Addendum No: 7
Date: February 9, 2024
Owner: Northern Health
Stantec # 144320228

Client/Project
Northern Health Authority
UHNBC (University Hospital of Northern BC) -
NAPRA Pharmacy Renovation
1475 Edmonton St, Prince George, BC V2M 1S2

Project No. 144320228
Revision B
Scale As indicated
Drawing No. **AE103**

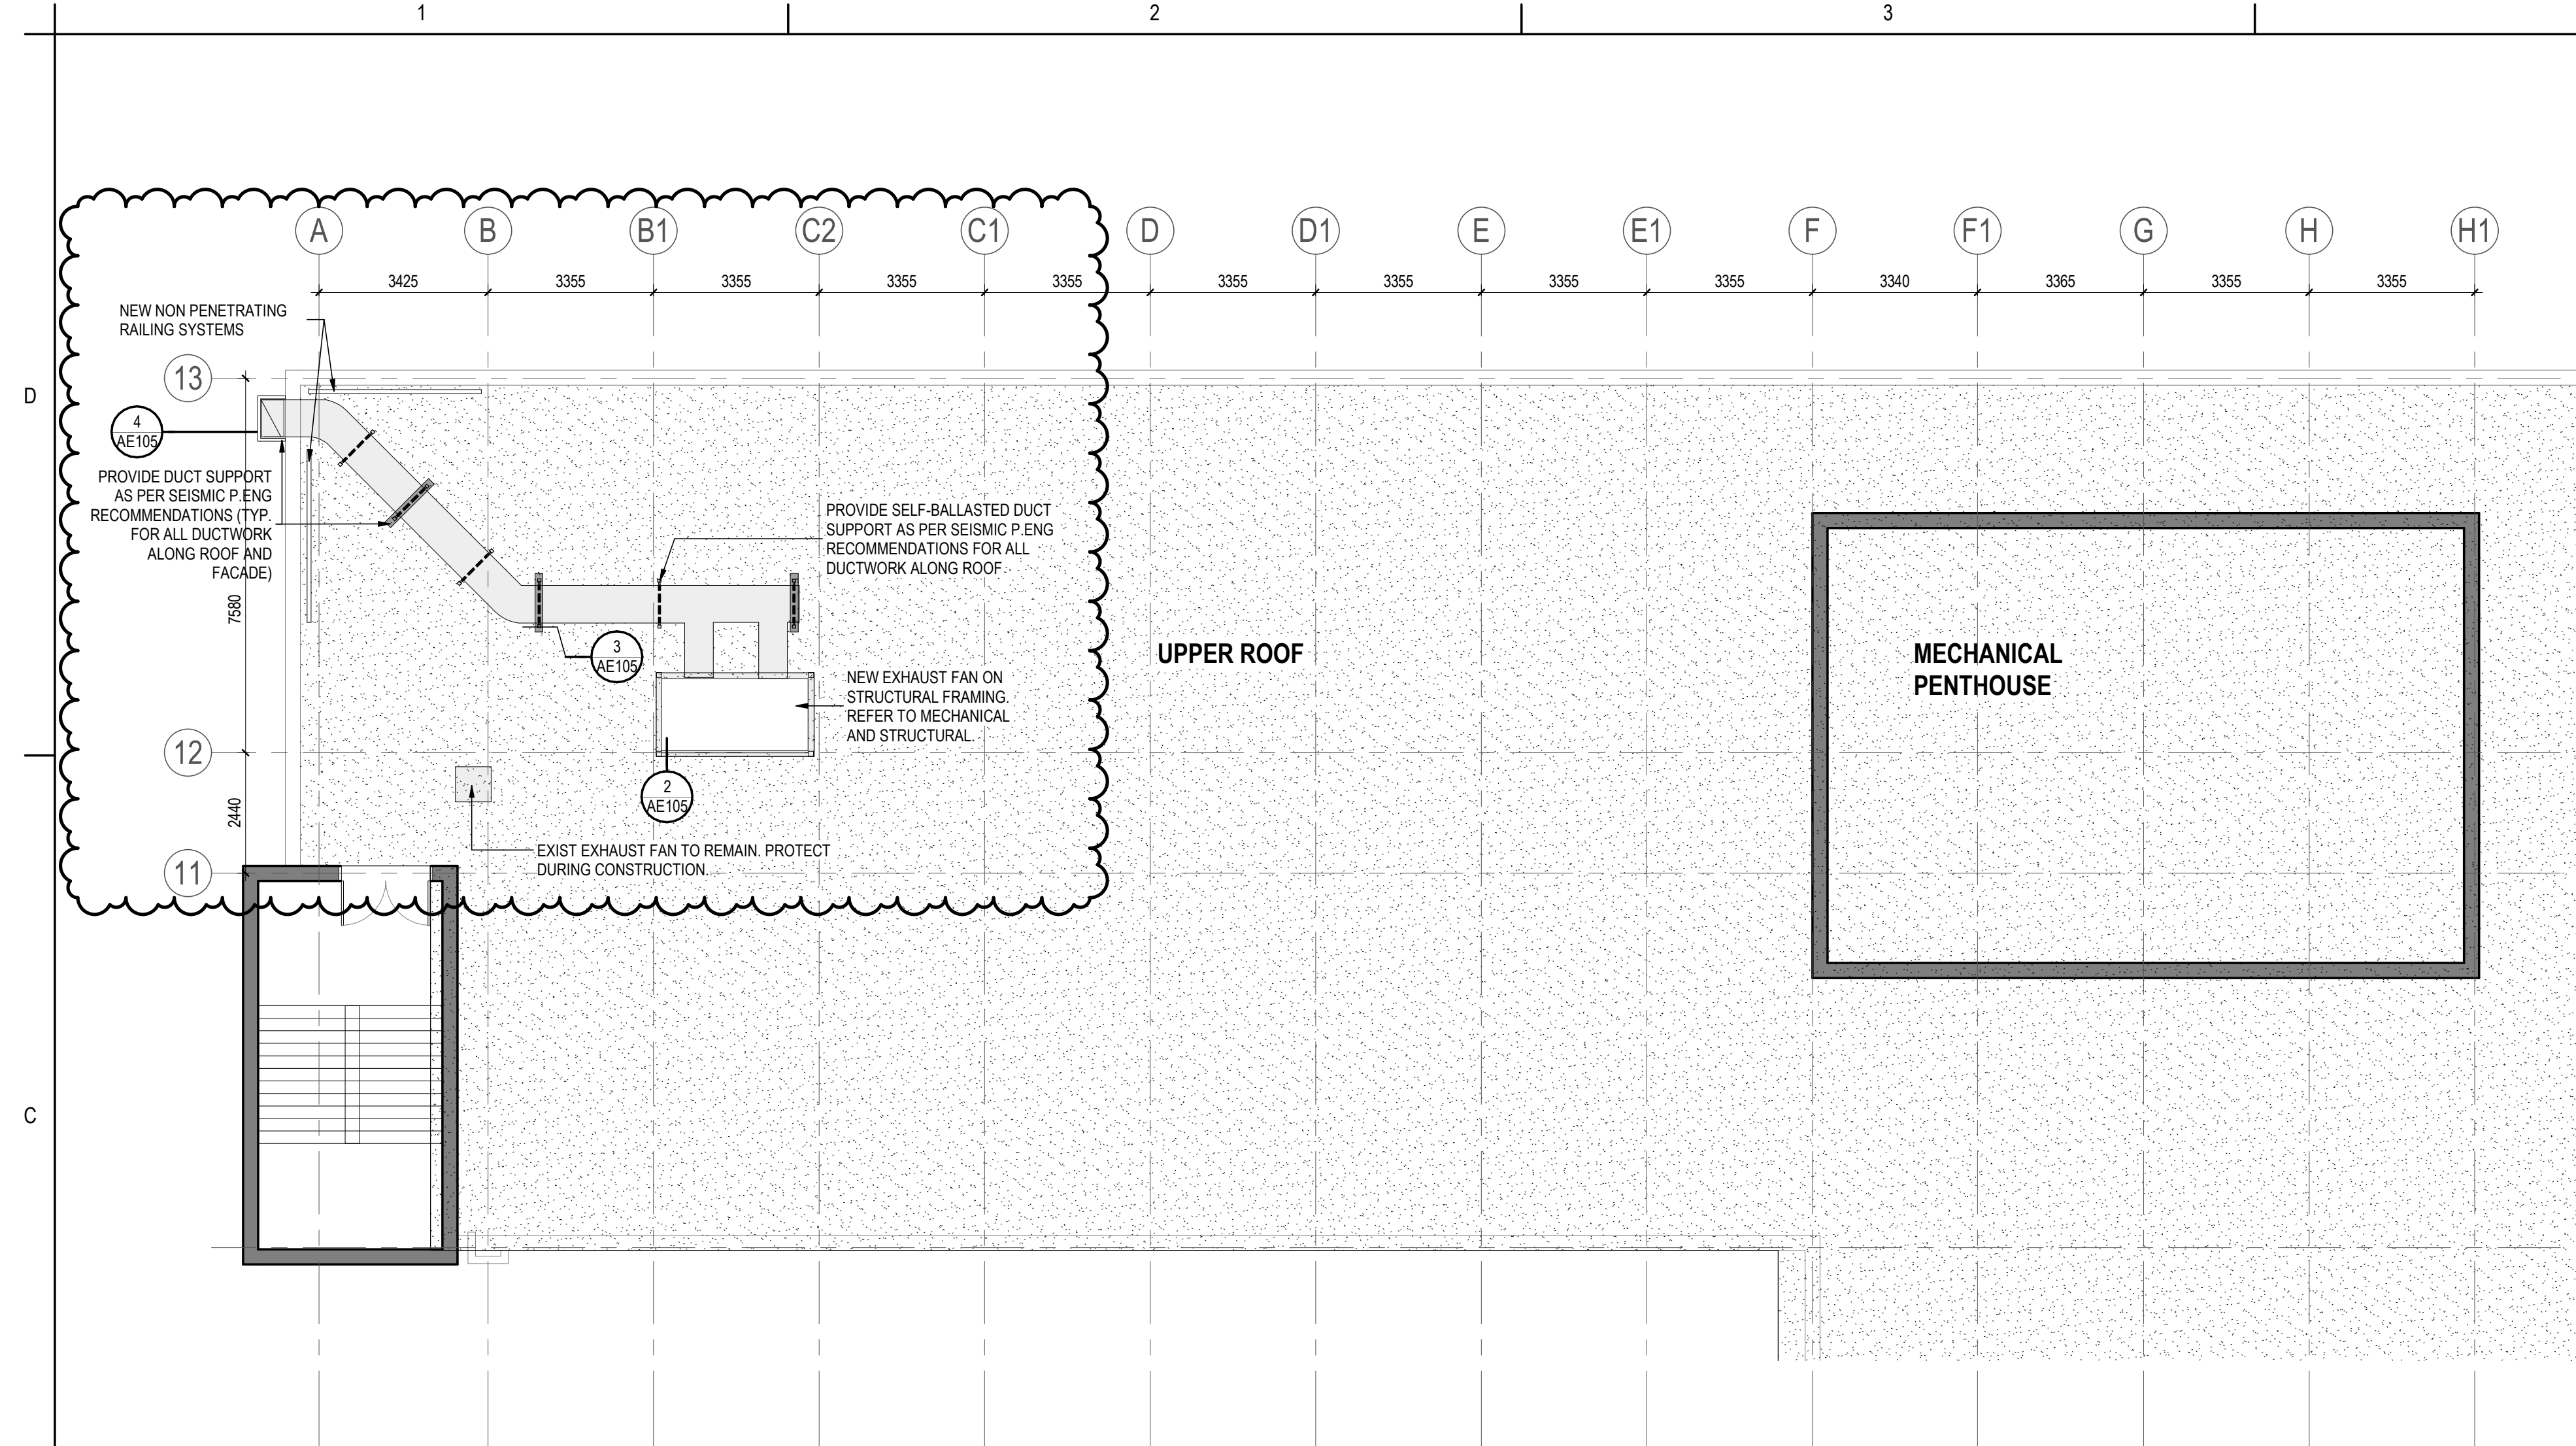
AE103 – Note updated for duct vertical support wall restrain.

Project No. 144320228	Scale As indicated
Revision B	Drawing No. AE105

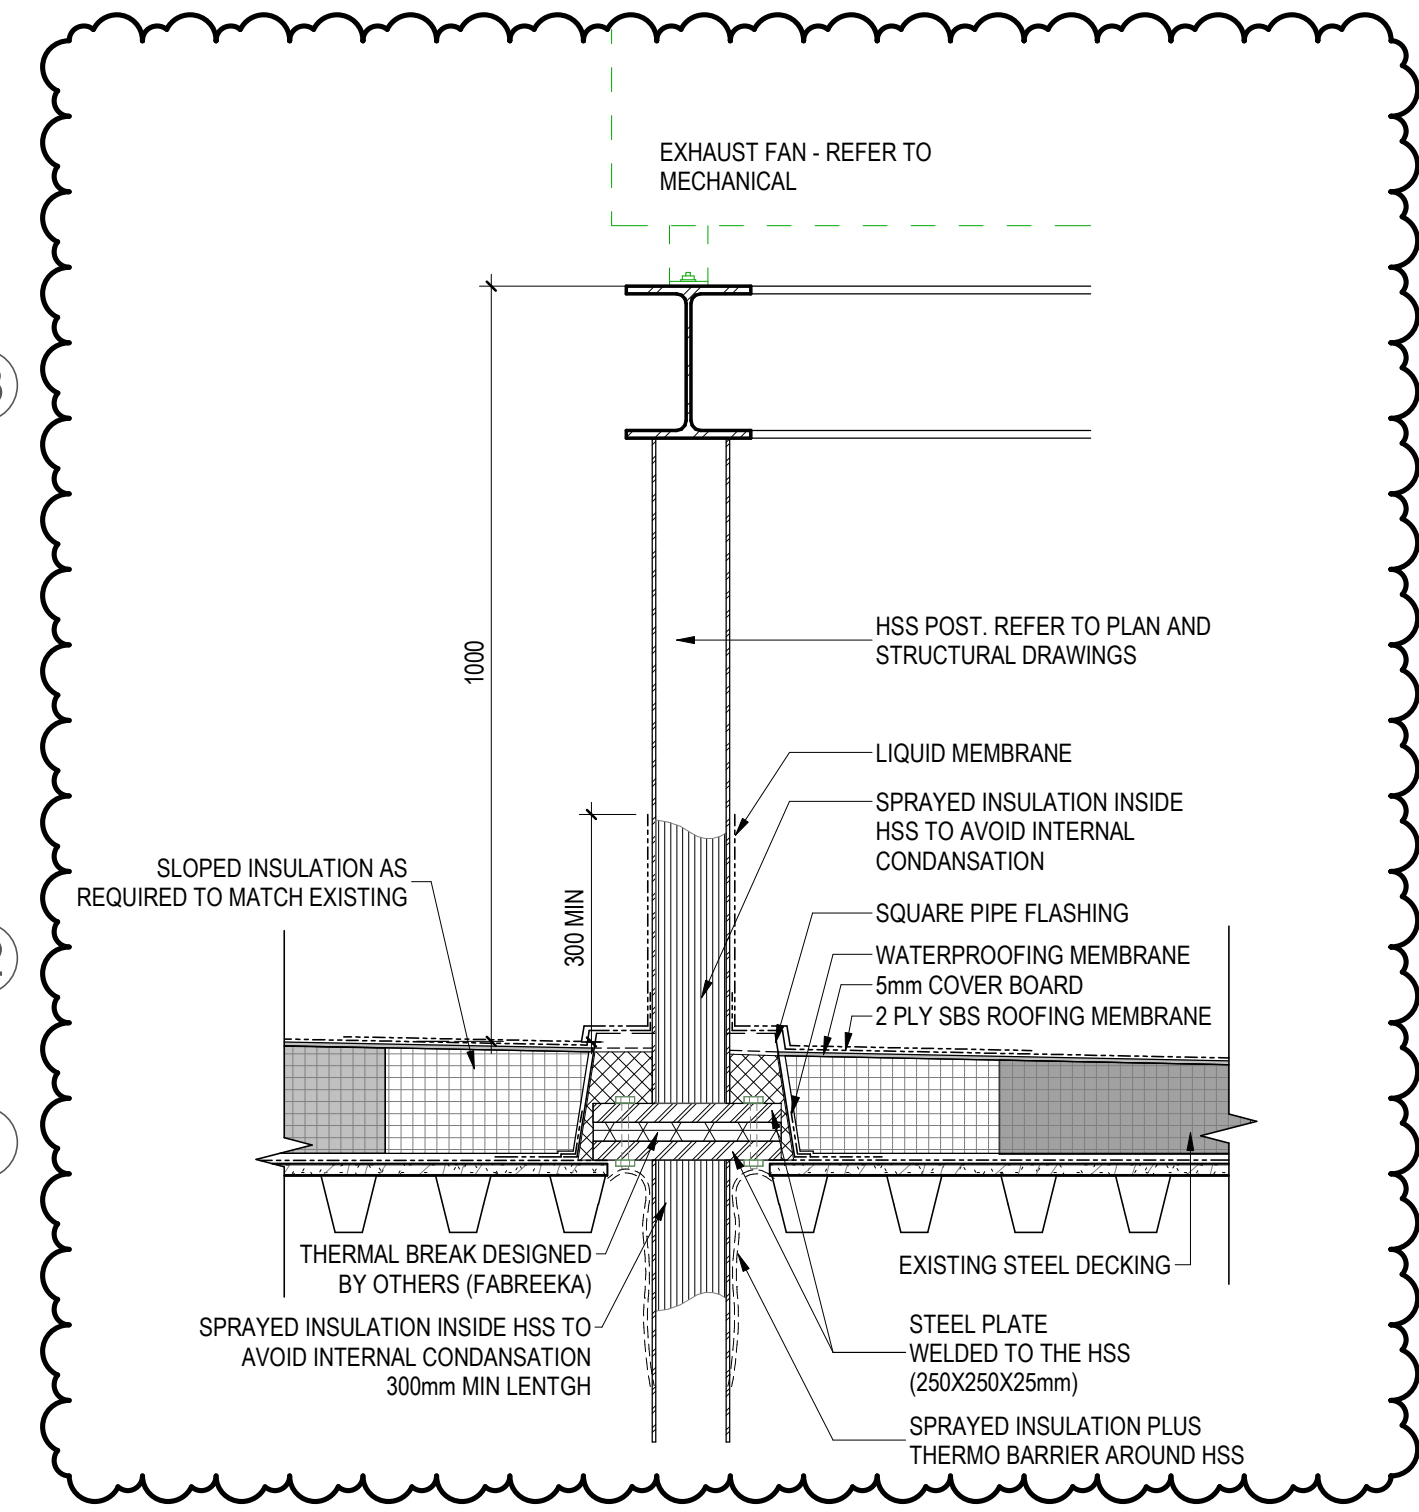
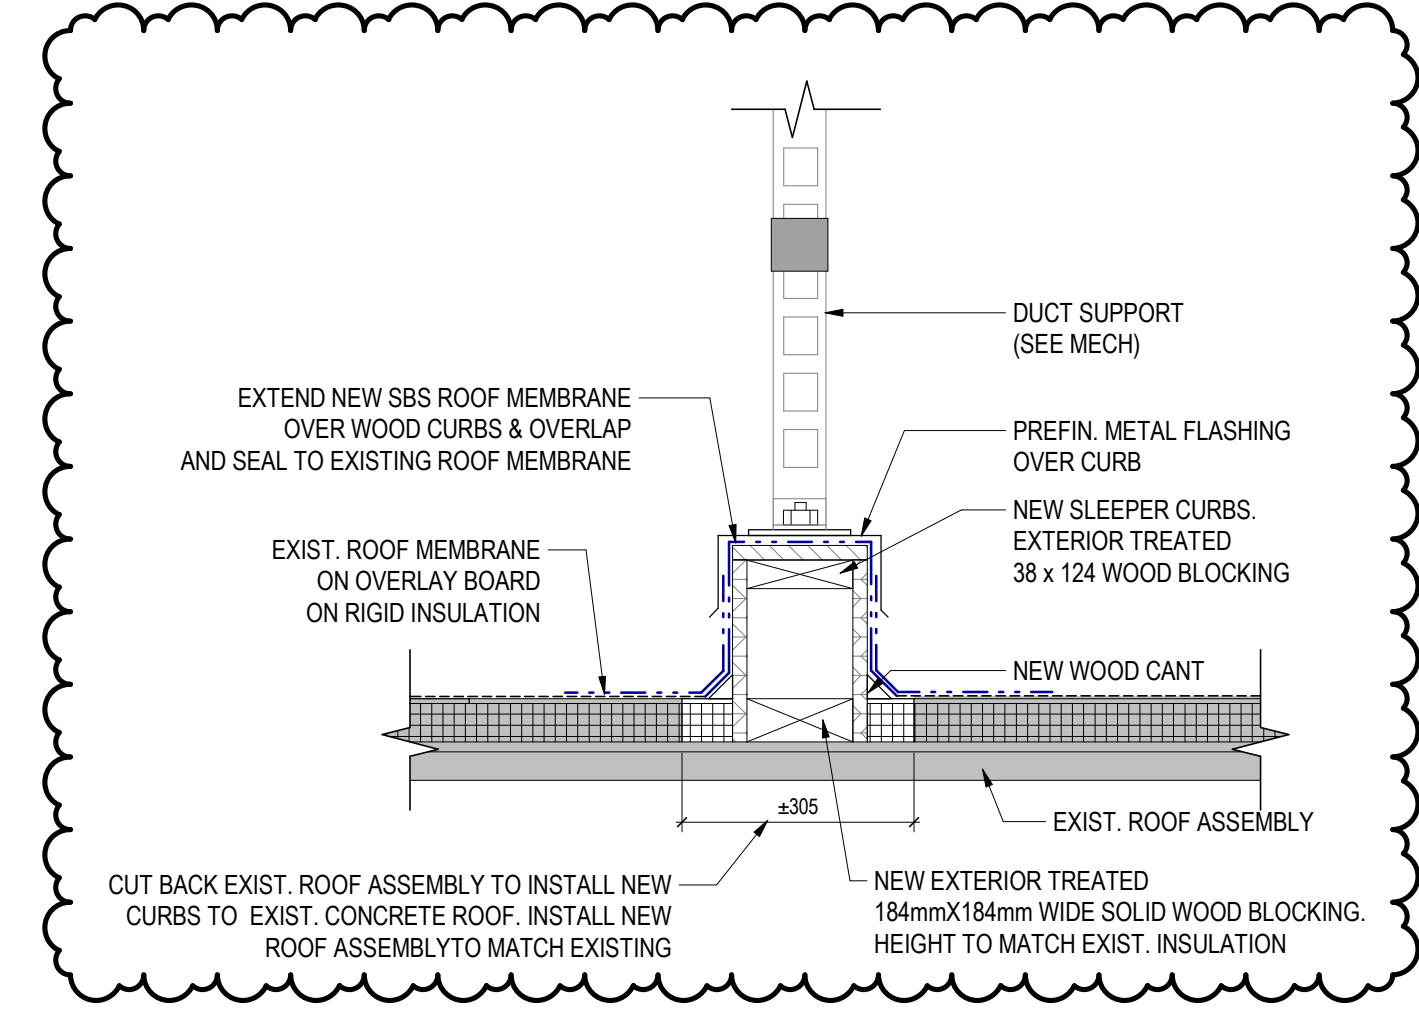
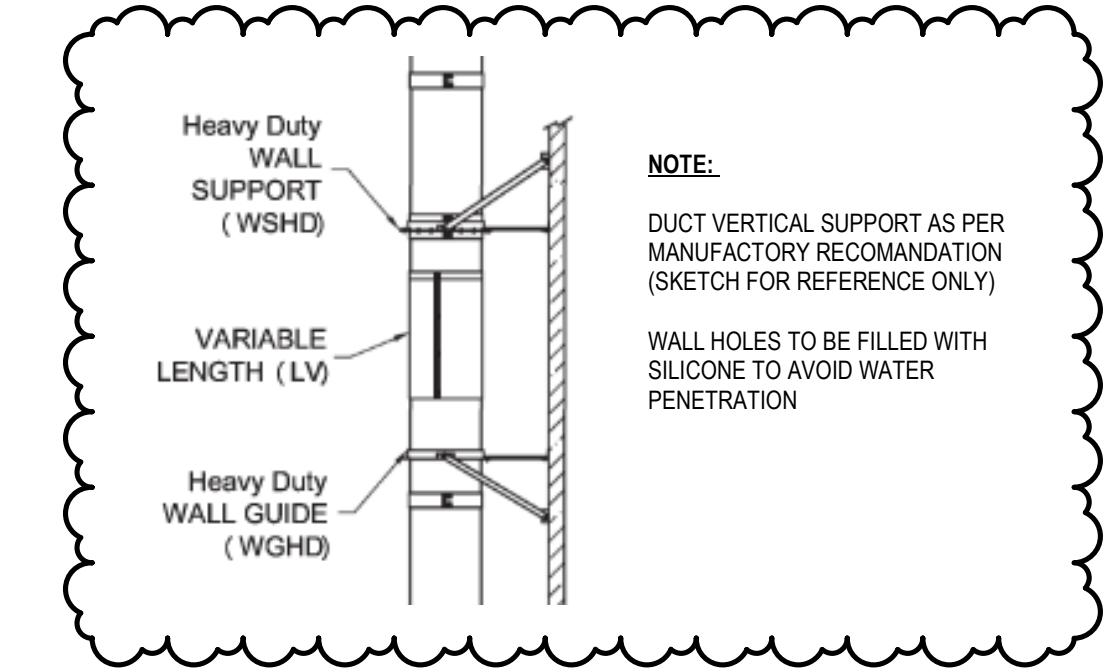
AE105 – Duct location updated including roof sleeper detail.

Question: Addendum #2-page 8 foam insulation –is intent to use the foam insulation on the exterior of the roof decking around the HSS? what about thermal bridging for structural steel extending from exterior to interior.

Question: Section 07 52 00 Guard Rail System-Please provide drawing showing location and quantity of the railing system.

Answer: Yes, thermal bridging required please see updated detail 2 pg. AE105.

Answer: Refer to drawing 2 pg. AE105
